SUBJECT: Design Memorandum on Pier Repair Project at
Olcott Harbor, New York

1. The design memorandum is approved subject to the following comments:

PIER REPAIR PROJECT

OLCOTT HARBOR, NEW YORK

TYPICAL CROSS SECTIONS OF REPAIR TO WEST PIER
SCALE: 1" = 4'

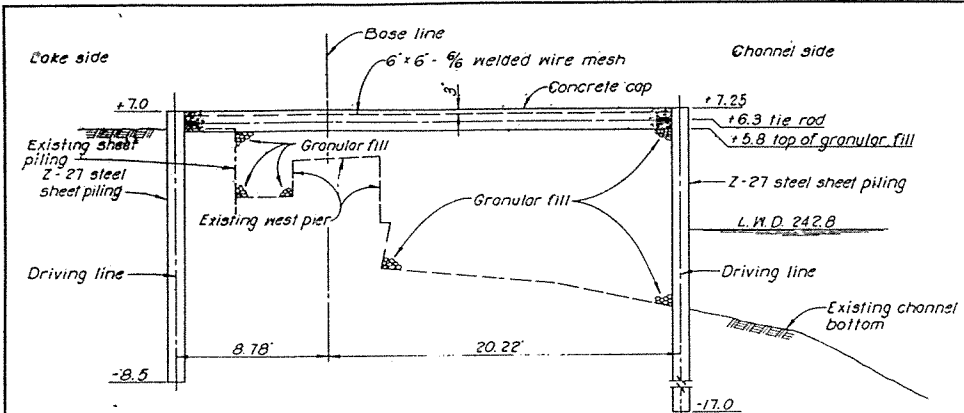
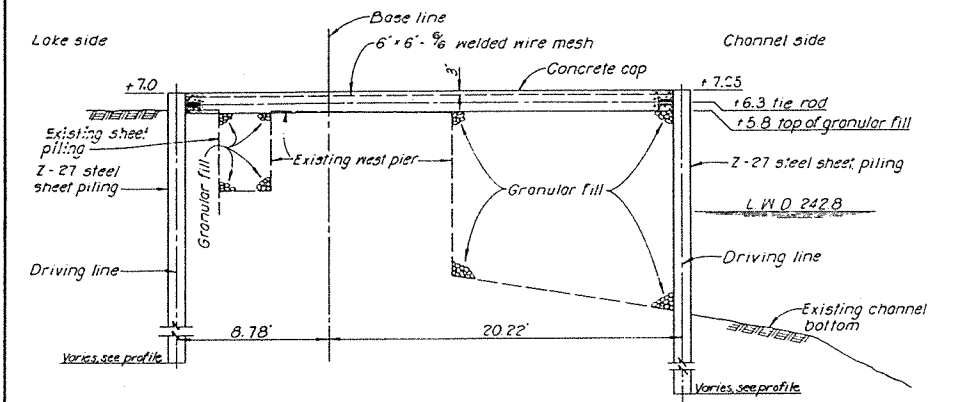
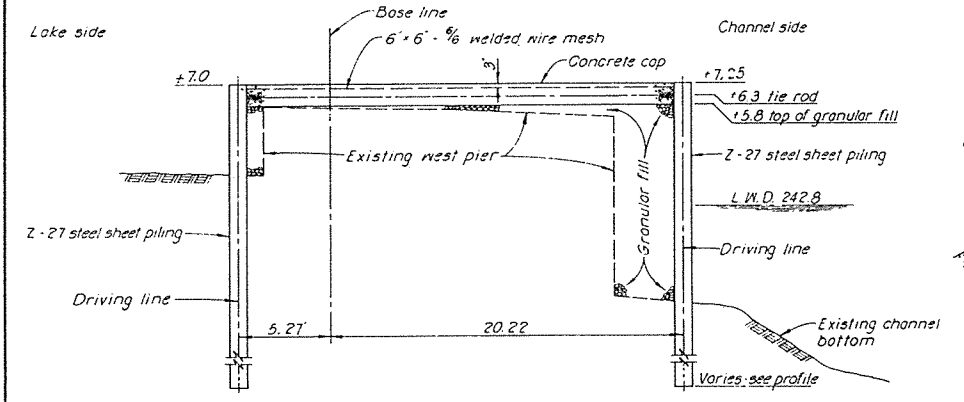
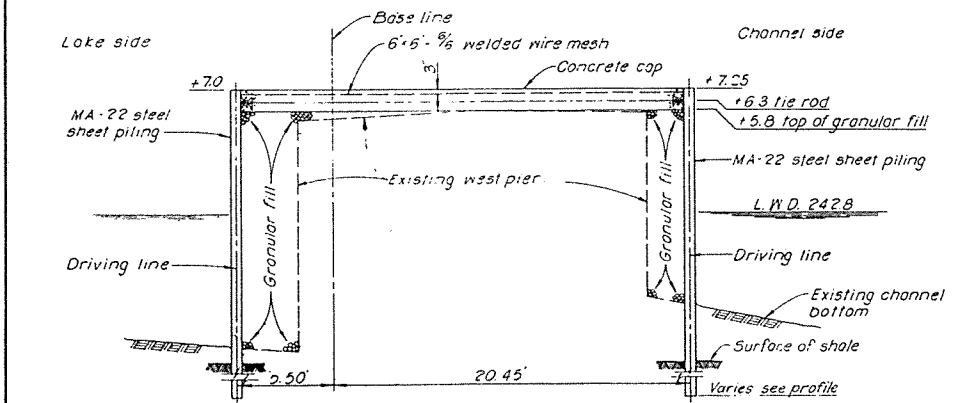
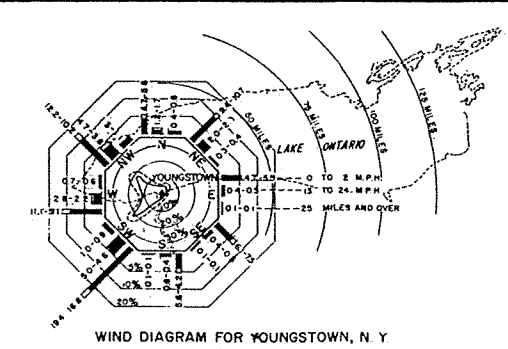
c. Consideration should be given to locating the wales on the outside surface of the piles rather than on the inside as shown on the Plate 1 cross-sections.

1. Forwarded for continuance of action.
2. Reference is made to paragraph 1c of the 2nd Indorsement. In telephone conversation mentioned in paragraph 2 of 2nd Indorsement, OCE was informed that comment would not receive favorable consideration in view of past experience wherein wales on outside of piling were damaged by wave action. Example cited was Presque Isle Peninsula, Erie, Pa. in the 1940's.
3. Foregoing confirms telephone conversation Mr. Amrein to Mr. Hunt on 5 April 1963.
4. The tentative approval of the plans and specifications set forth in NCD 1st Indorsement dated 4 April 1963 on Buffalo District letter dated 8 March 1963 is hereby revised to final subject to comments in the 4 April NCD Indorsement and those set forth in the preceding 2nd Indorsement.

BORINGS TAKEN IN 1940 & 1948

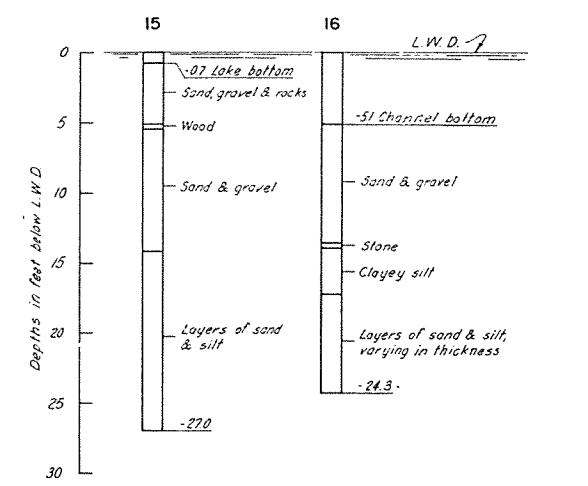
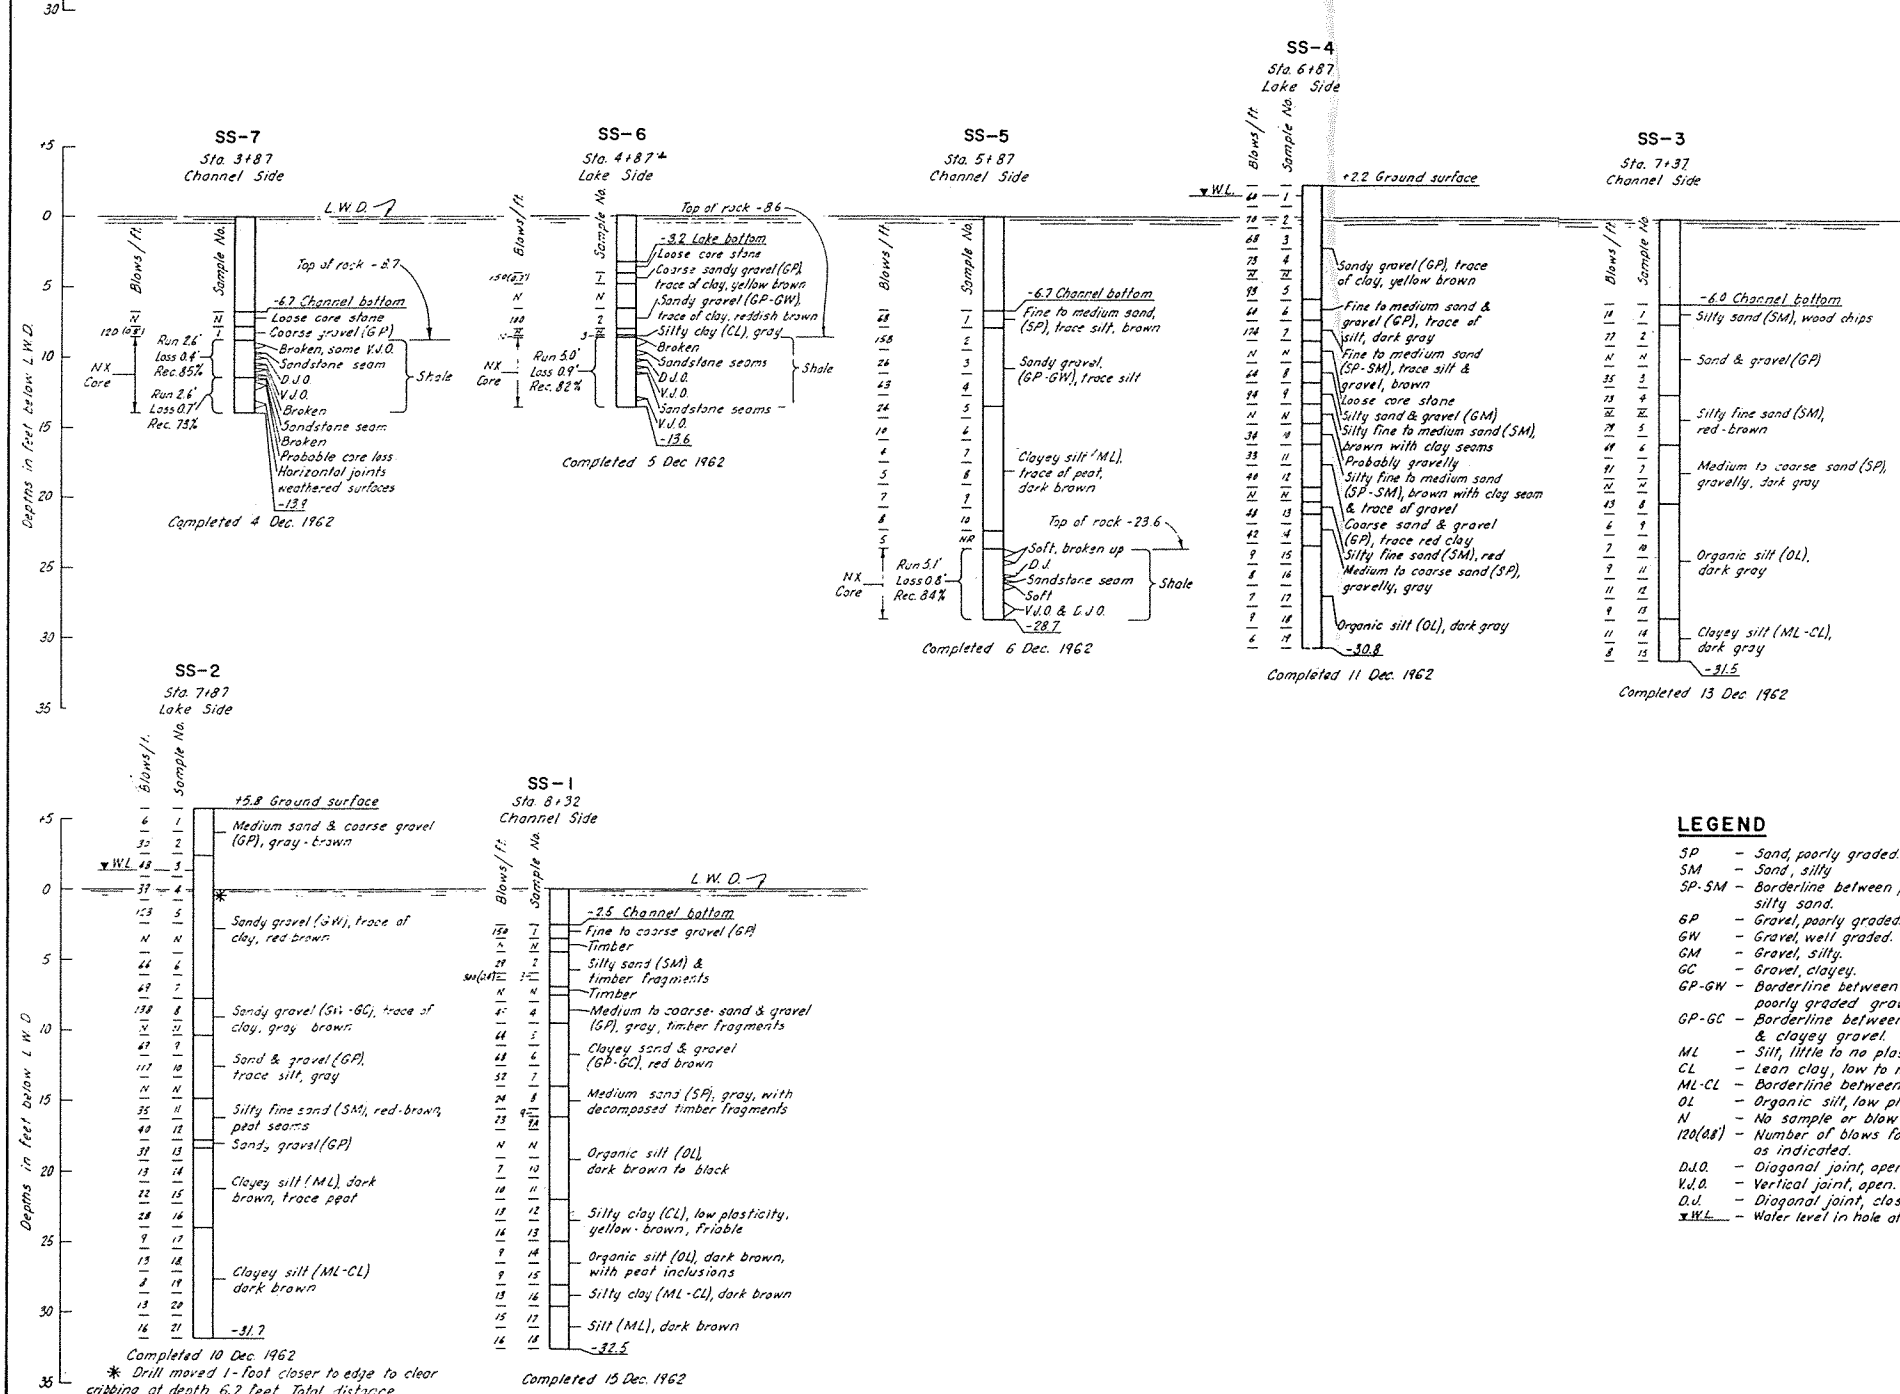
a. Referring to Plate 3.

(1) Inasmuch as the descriptions, especially those for the rock, on the logs for borings made in 1940 and in 1948 do not agree with those shown on the logs for the more recent borings, some indication of the reliability of the descriptions or an explanation for the disagreement should be given if this drawing is to be included in the contract drawings.

(2) Also, it is the understanding of persons in this office that cores and samples from the 1940 and the 1948 explorations are not now available for inspection. If this is true and if the drawing is to be one of the contract drawings, the lack of availability of these cores and samples should be indicated.

(3) In note 4, this office questions the description of the shale as "hard" inasmuch as a hard rock is one that cannot be scratched with one's fingernail (Plate 2, EM 1110-1-1806). Maybe definitions of hardness terms should be included in the drawing.
